**EPA Superfund
Record of Decision Amendment:**

**Brio Refining Inc.
Friendswood, TX
7/2/1997**

**BRIO REFINING SUPERFUND SITE
HOUSTON, TEXAS
AMENDED RECORD OF DECISION
DECLARATION**

**BRIO REFINING SUPERFUND SITE
HOUSTON, TEXAS
AMENDED RECORD OF DECISION
DECISION SUMMARY**

Figure 1 - Brio Refining Site Map

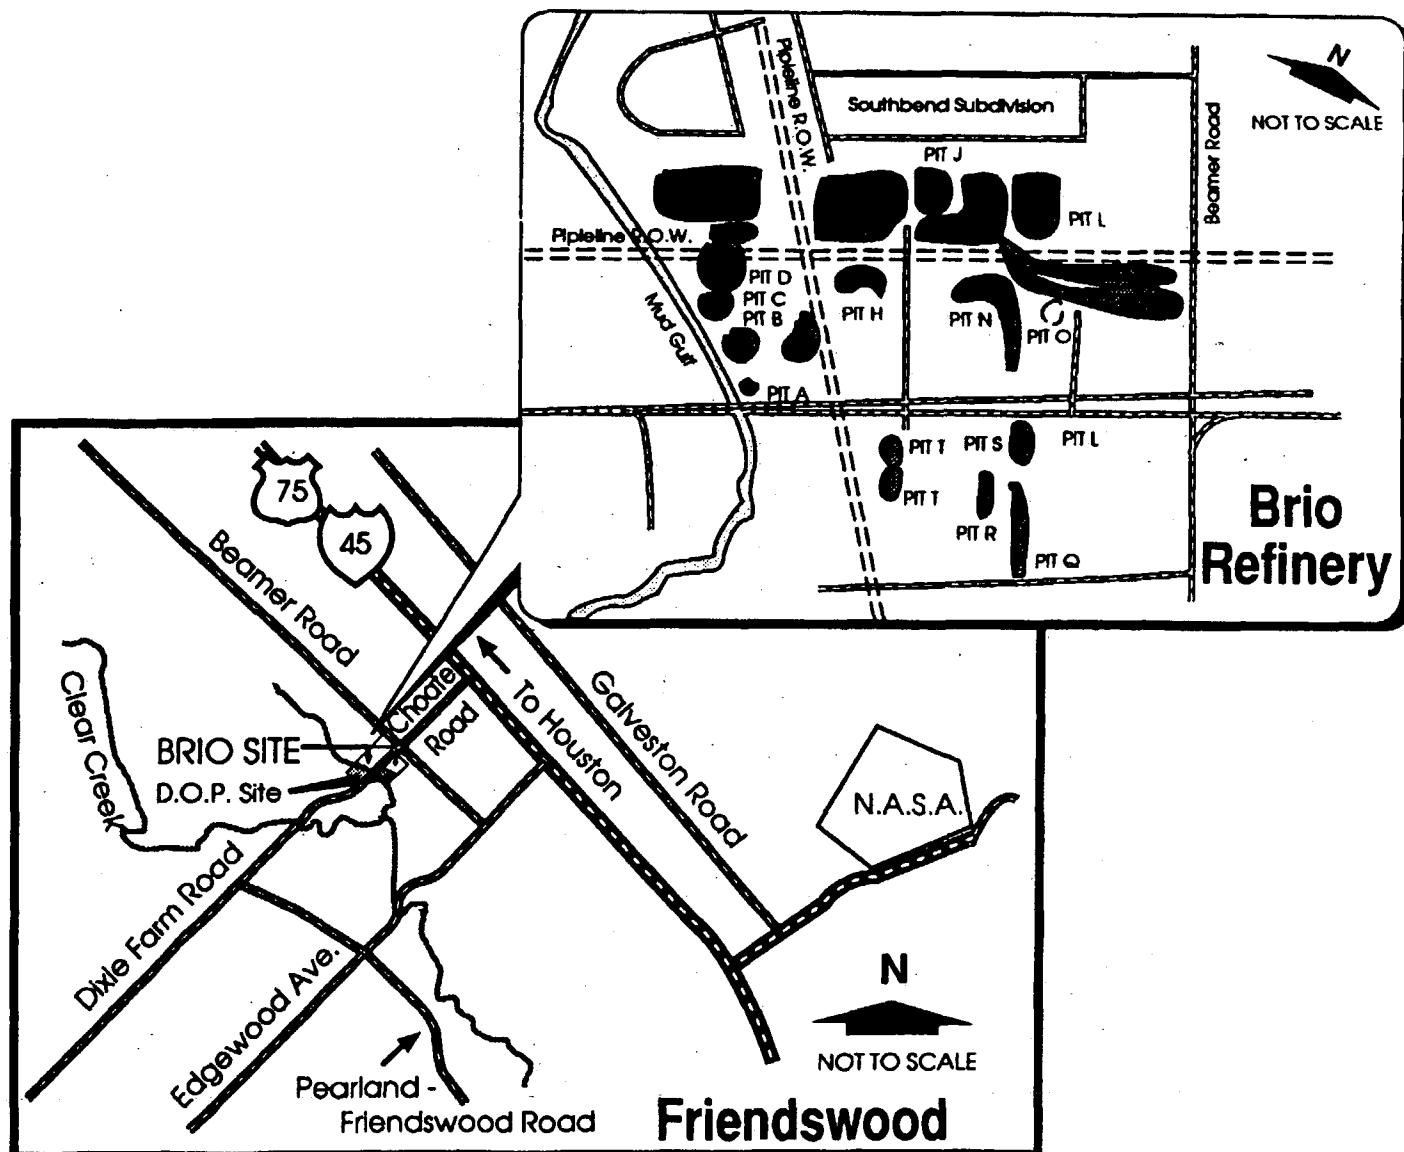
19. Comment - The description of the composite cap should be clarified in the text to note that the cap will not be installed to the limits of the barrier wall over DOP South.

Site Cover - A composite cap will be constructed over the site, extending to the limits of the barrier wall (not including Dixie Oil Processors South, see Figure 2). The cap will include a gas collection layer, a flexible membrane liner, compacted clay, and top soil to promote vegetative growth.

Response: The text has been modified to incorporate this comment.
